## CUMBERLAND DESIGN EXCELLENCE PANEL

### MEETING MINUTES

<b>DATE OF MEETING</b>	04/06/2025
<b>MEETING LOCATION</b>	online
<b>PROPERTY ADDRESS</b>	2 Mark Street, 1A, 1 and 3 Marsden Street, Lidcombe being Lots 7 to 12 Section 12 in DP 846.
<b>FILE No.</b>	DA2025/0095 and PPSSCC-679.
<b>PANEL MEMBERS</b>	Sandor Duz, Krista McMaster, Clare Johnston
<b>APOLOGIES</b>	NIL
<b>ATTENDEES</b>

The development application is proposing the demolition of existing structures and construction of a mixed-use development comprising six (6) commercial tenancies, 107 co-living rooms and 306 boarding rooms and three (3) levels of basement car parking (Pursuant to State Environmental Planning Policy (Housing) 2021).

### **Basement**

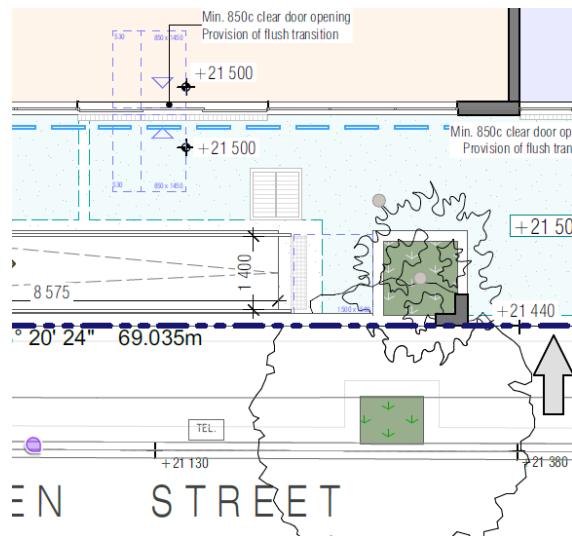
- Provision of bike parking is a positive – may be better defined in a secure room/area noting that there is a shared lift between commercial and residential areas and to maintain a tidy appearance
- NOTE: Updates to AS 2890:1 are imminent - minimum parking space size 2.4m x 5.6m
